### V2500-A1 SERIES PROPULSION SYSTEMS SERVICE BULLETIN

This document transmits Revision 2 to Service Bulletin V2500-ENG-72-0353

## V2500-ENG-72-0353

### MODIFICATION SERVICE BULLETIN - ENGINE - LP COMPRESSOR - INTRODUCTION OF REVISED RETAINING SPIRAL RING

Location of the Retaining Spiral Ring  
Figure 1

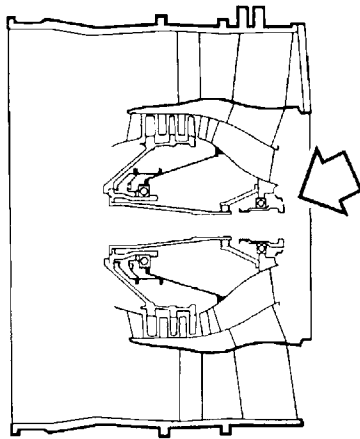
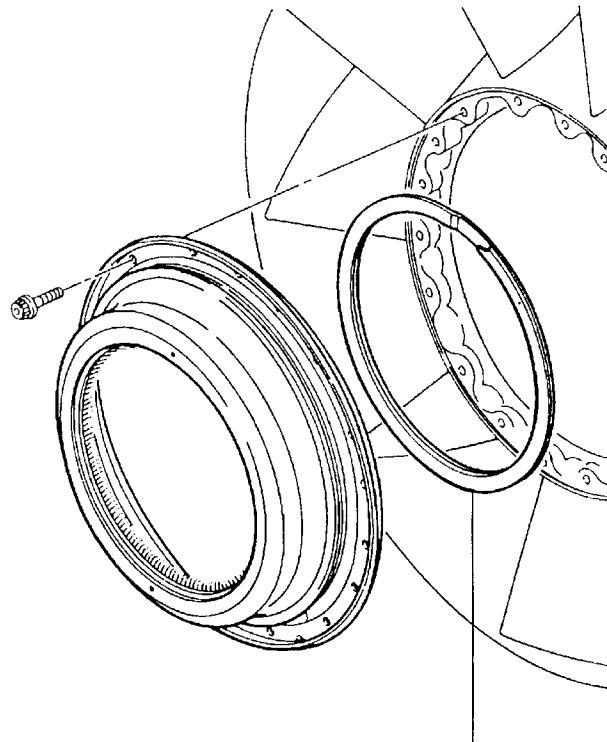
INSTALL THE 5R0287 RETAINING  
SPIRAL RING(1 off)

View of rework of the Retaining Spiral Ring  
 Figure 2

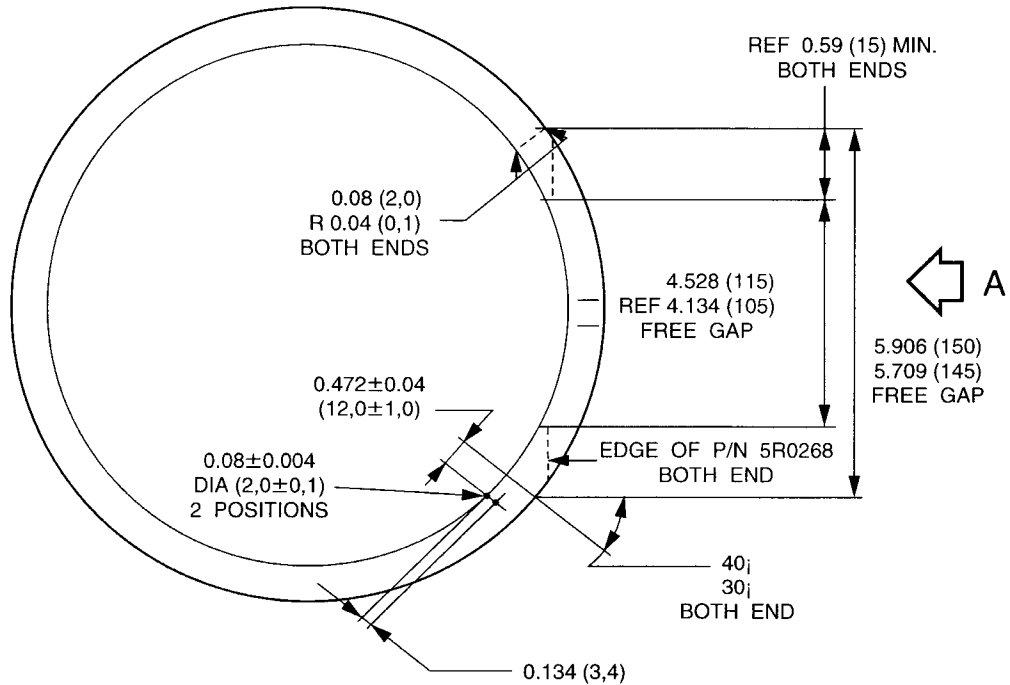
(c) The old retaining spiral ring can be reworked (Refer to Figure 2).

- (1) Rework the retaining spiral ring as follows (Refer to Figure 2):
  - (a) Cut the edges with standard work shop equipment take care not to damage the other surface, (if necessary, P/N 5R0268 only).

- (b) Drill the holes in the areas shown with the drilling machine and standard work shop equipment.
  - (c) Remove any sharp edges with standard work shop equipment.

- (d) Do a local penetrant crack test on the rework area with CoMat 06-022 fluorescent penetrant and penetrant inspection equipment, refer to SPM TASK 70-23-05-230-501.

- (e) Visually examine and measure the dimensions of the reworked areas.
  - (f) Delete current part number (P/N 5R0056 or 5R0268) with a single line and renumber with new part number (P/N 5R0287) adjacent to existing part number by vibrating marking pencil.

- (g) Apply the dry film lubricant with CoMat 10-005 colloidal molybdenum disulphide in toluene, refer to SPM TASK 70-38-03-380-501.
